Product code: CH76

Description: Anglewinder LMP 0.0mm offset Boxer/Flat motor mount - EVO6

New product / replacement: New

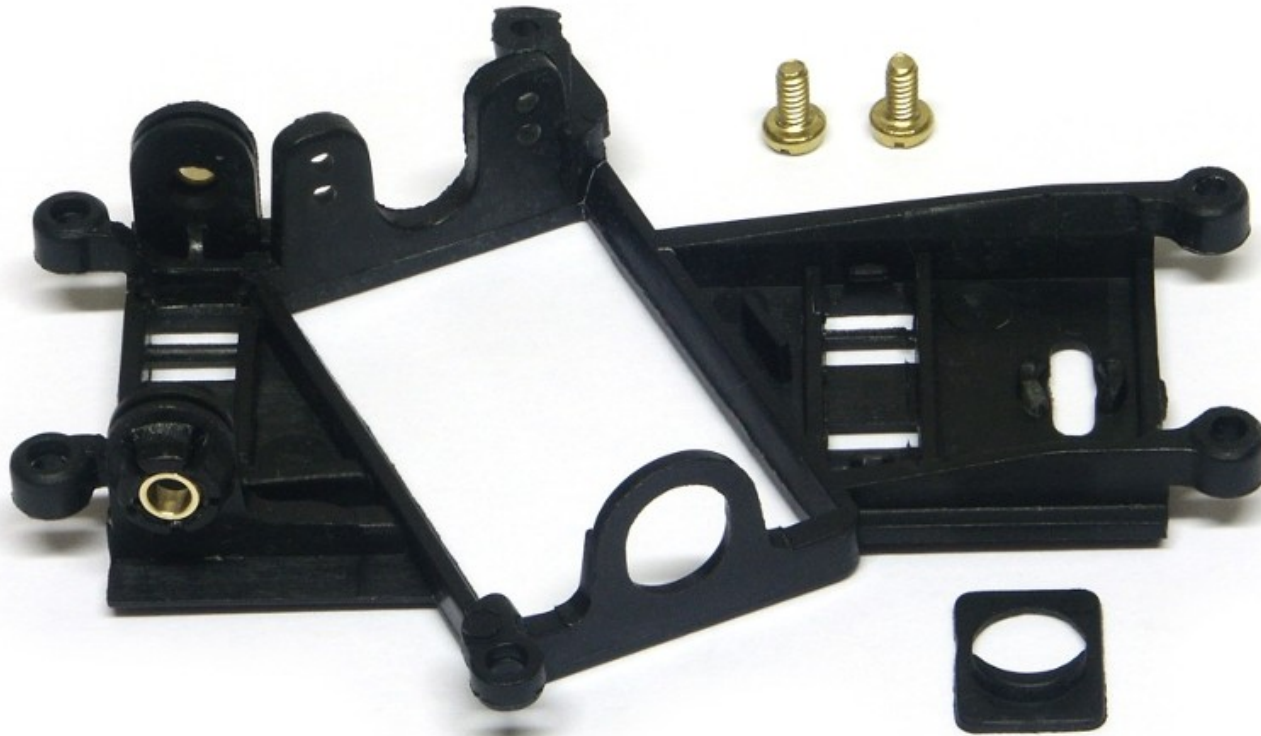
- Softer material compared with the CH61 (nylon and 30% fiberglass).
- 6 screws.
- 3rd bushing location (central) eliminated.
- one more location for magnet (or for SP23 ballast) added under the axle.
